SYSTEM: ADVANCED LIGO SUB-SYSTEM: AOS

PART NAME		DESIGNER		DATE	SIZE	DWG. NO.	REV.
SLC EDDY CURRENT DAMPING 8 DIA TUBE ASSY		N.Nguyen		01 Jun 2010	D	D1002564	v4
DRAFTER		N.Nguyen		24 AUG 2010			
CHECKER		M. Smith		01 NOV 2010			
APPROVAL		D. Coyne		10 NOV 2010	SCALE: 1:2	PROJECTION:	SHEET 1 OF 2

FRONT VIEW
01-LEFT MOUNTED COPPER PLATE
(ARM CAVITY BAFFLE)

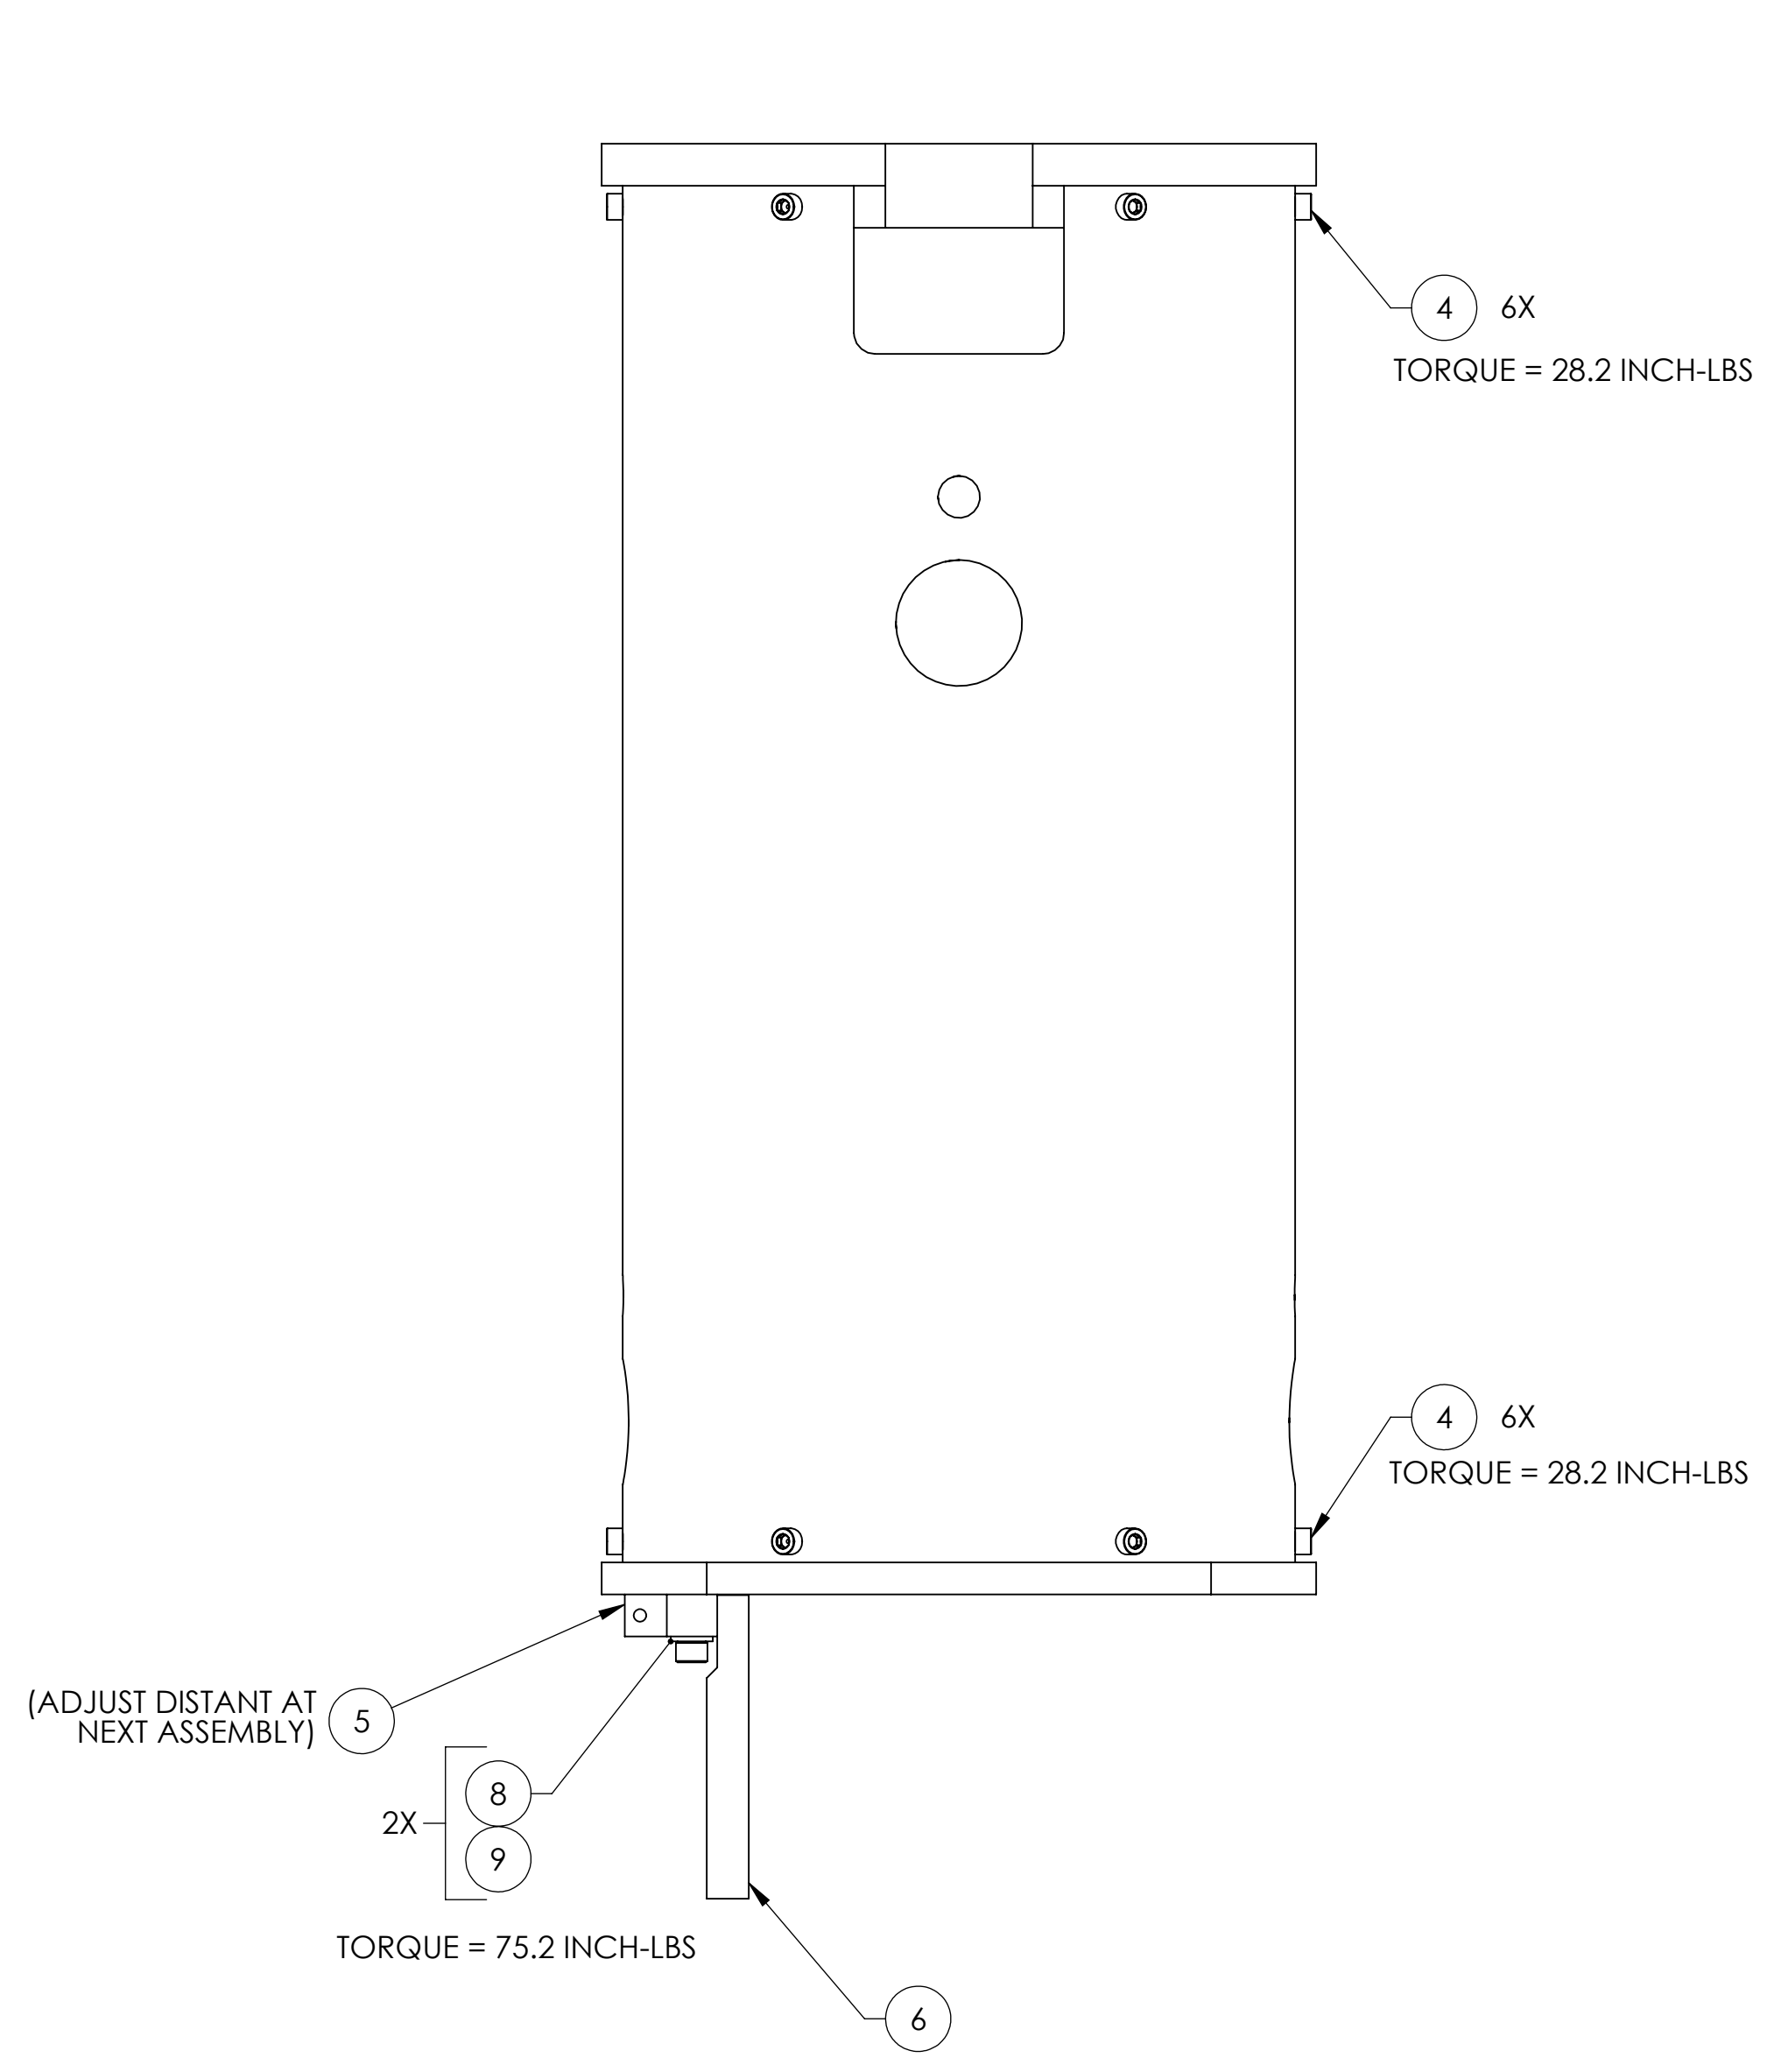
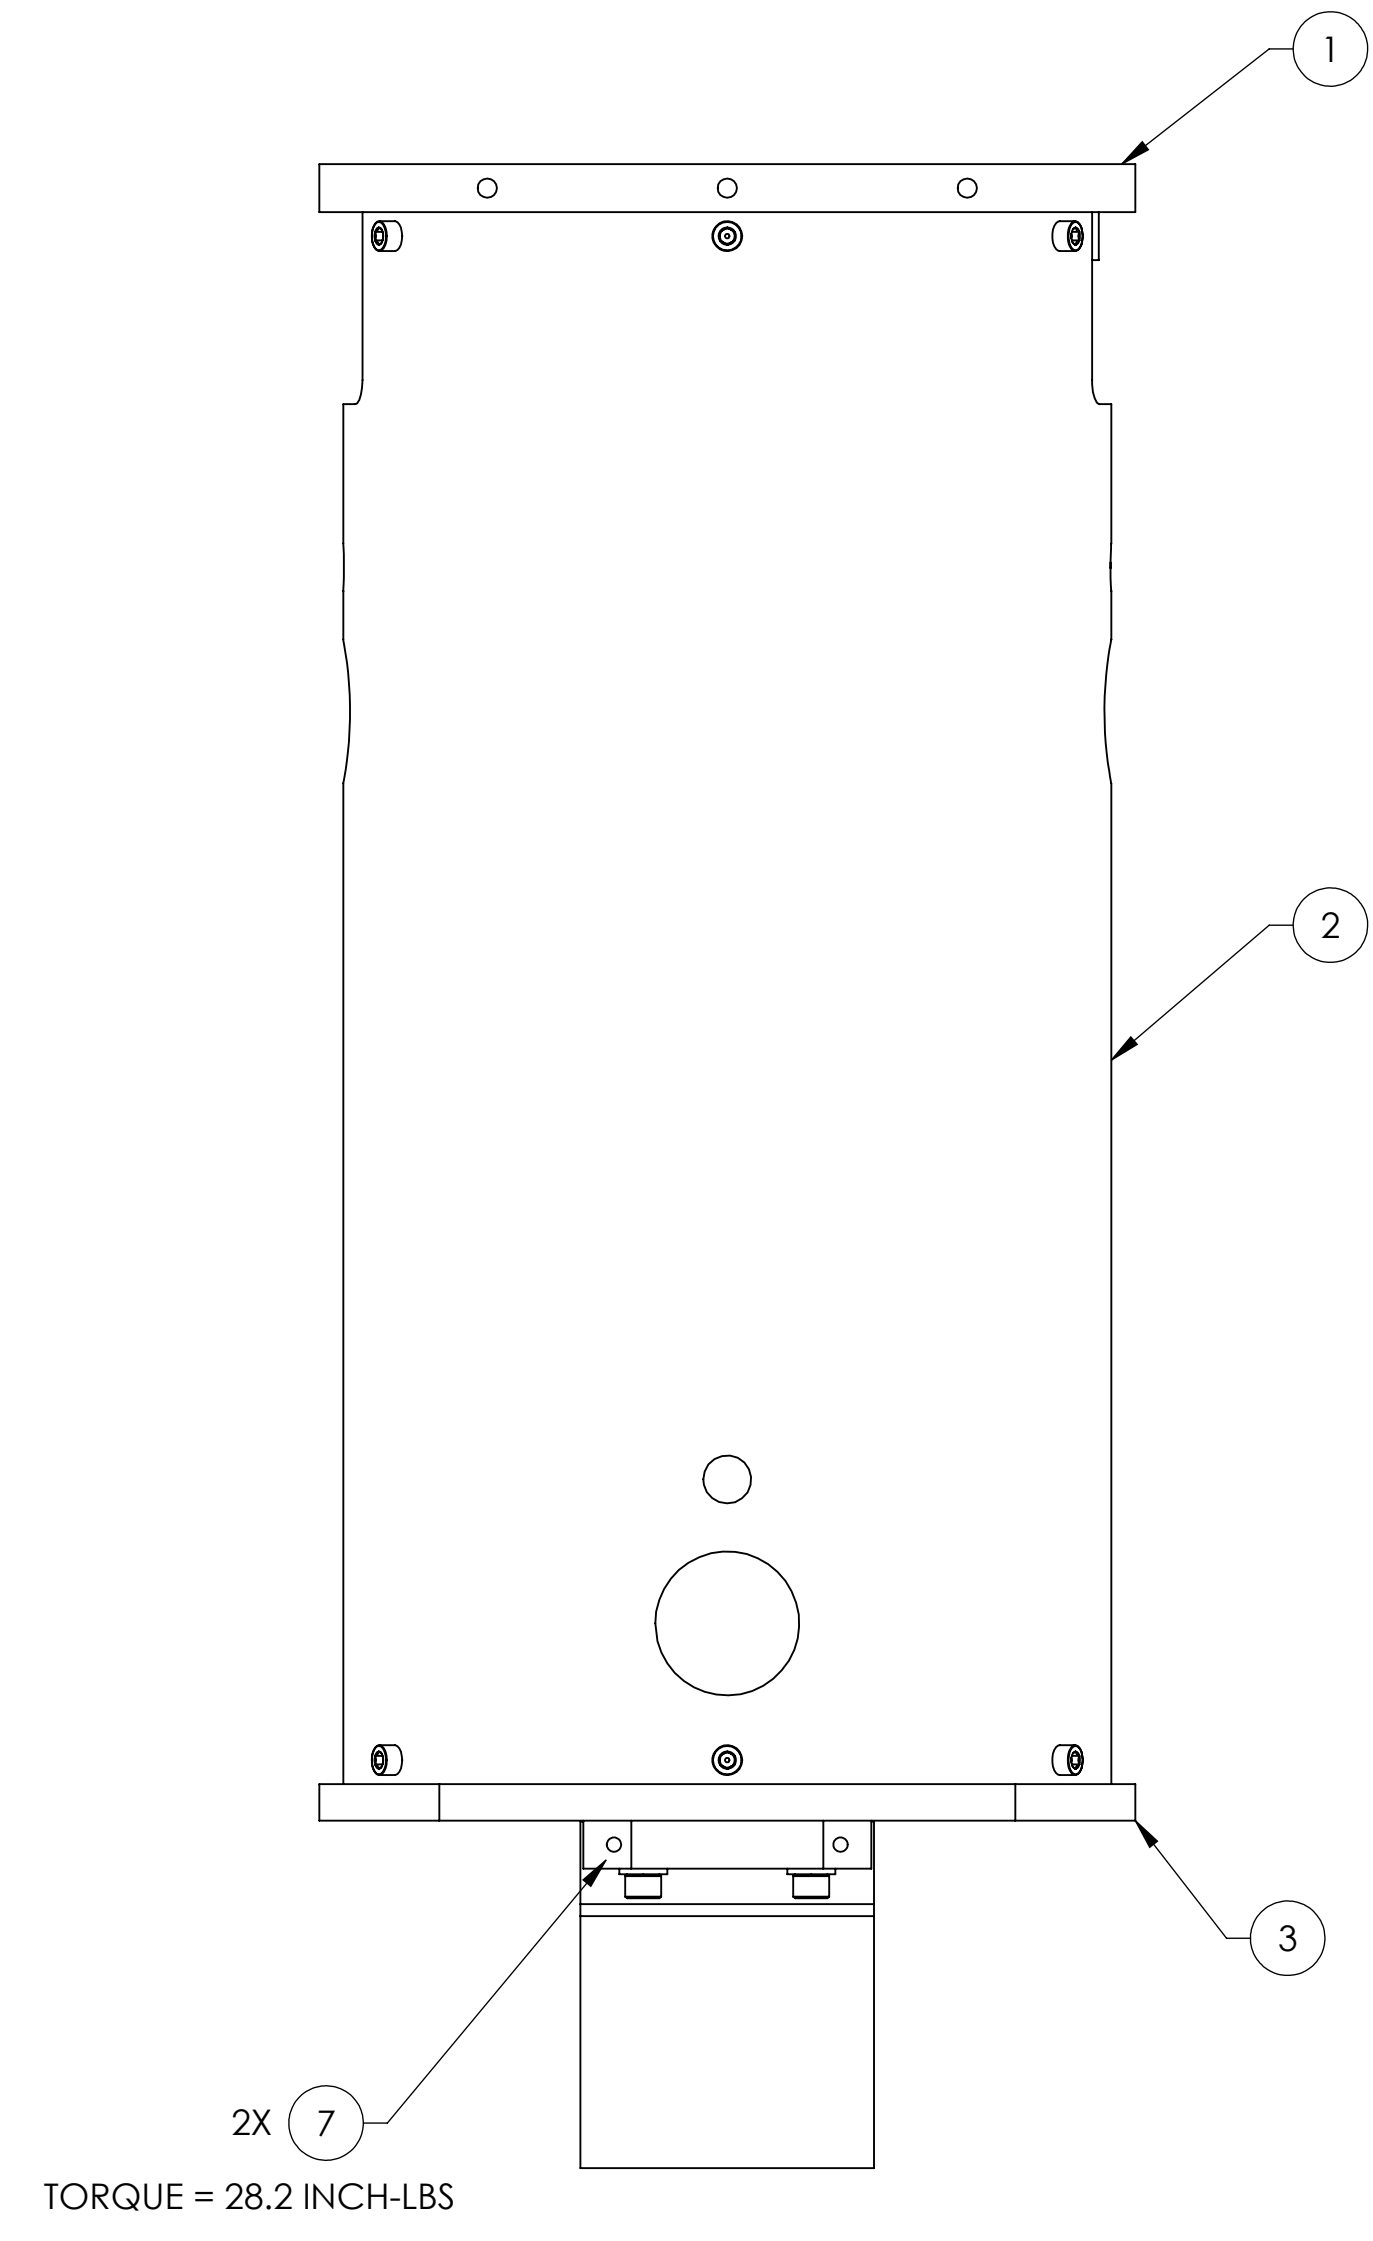
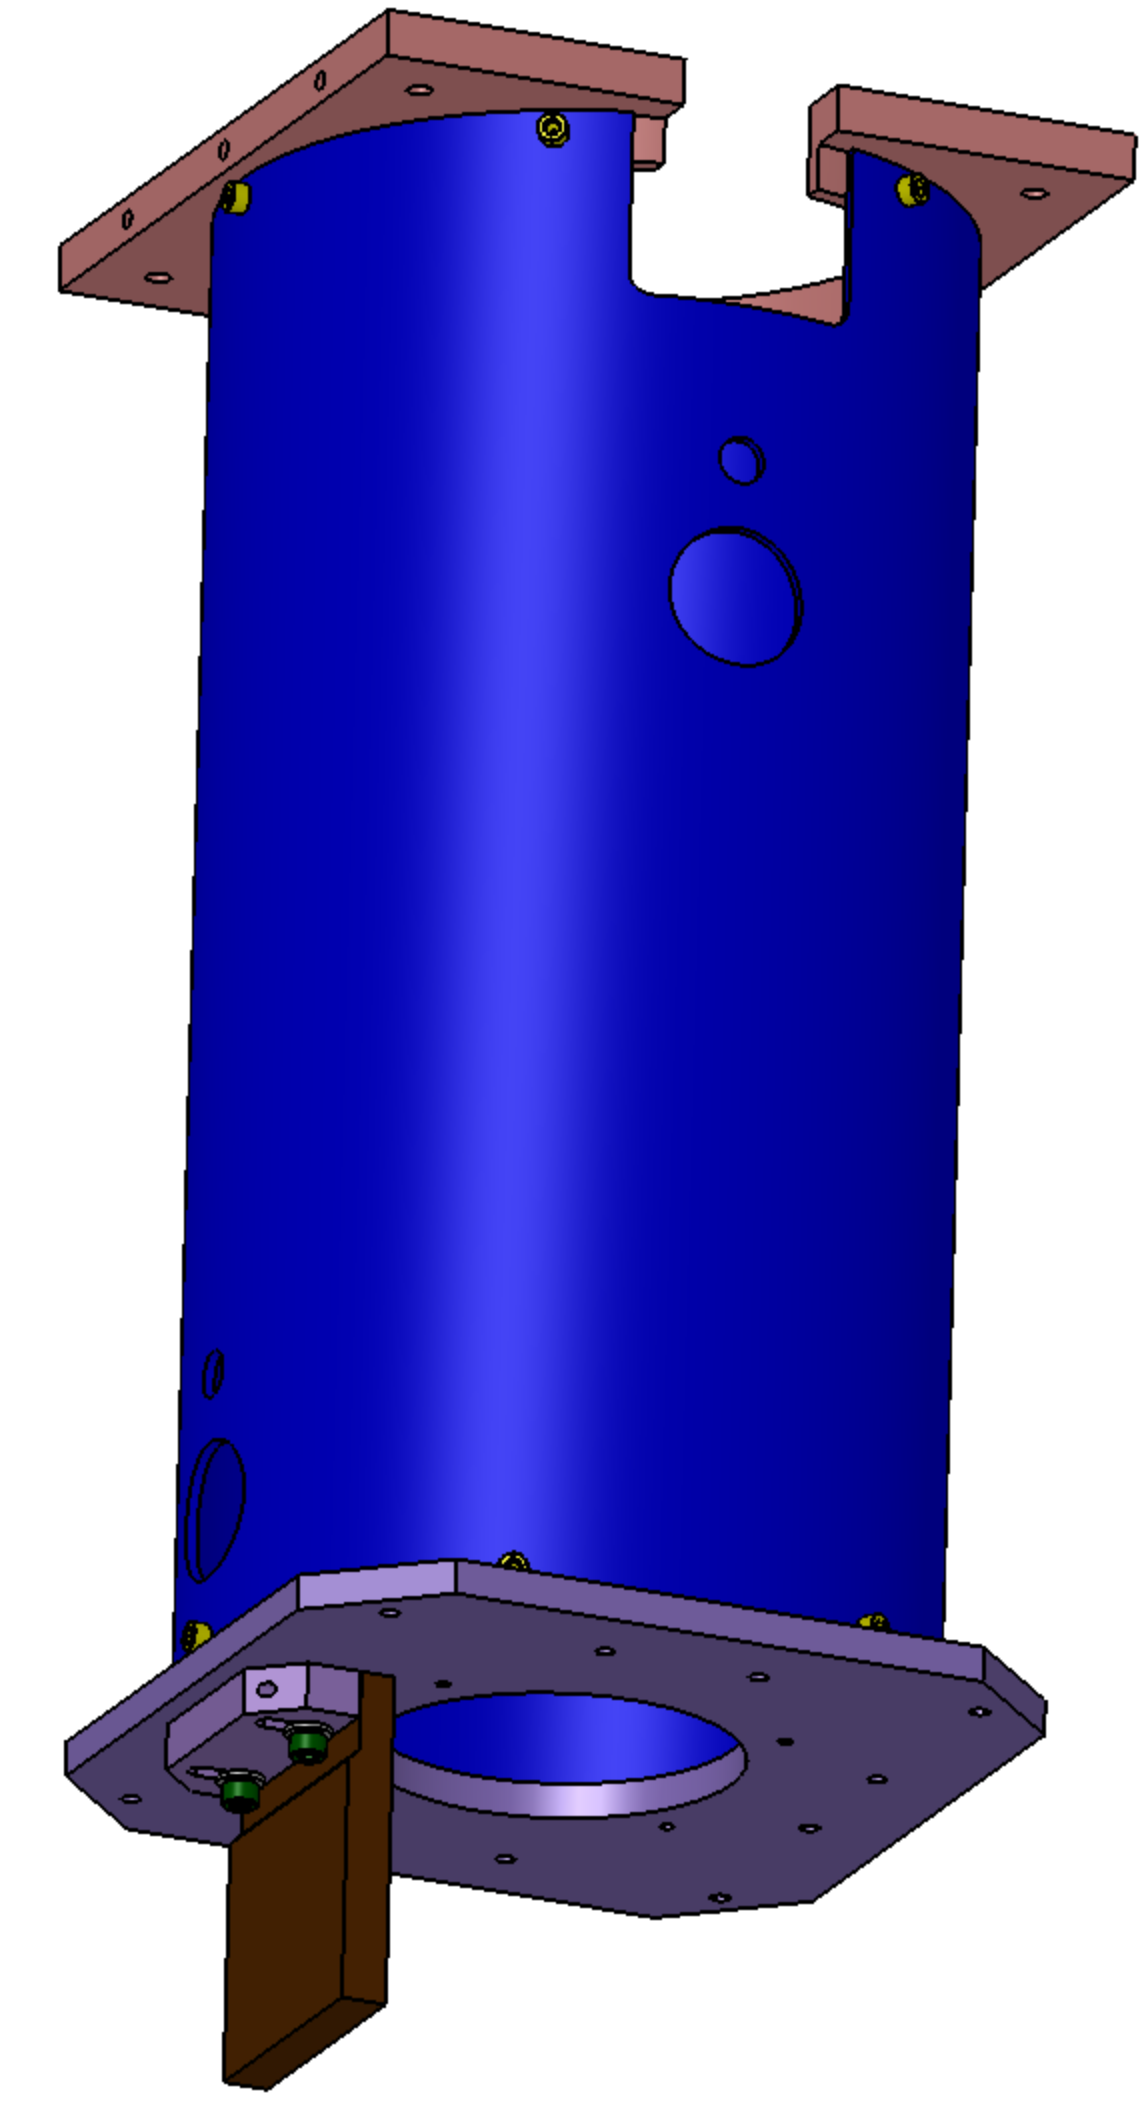
Drawing needs update -
1) Copper Plate modification
2) Add V1156 2-116 O-rings, qty = 2
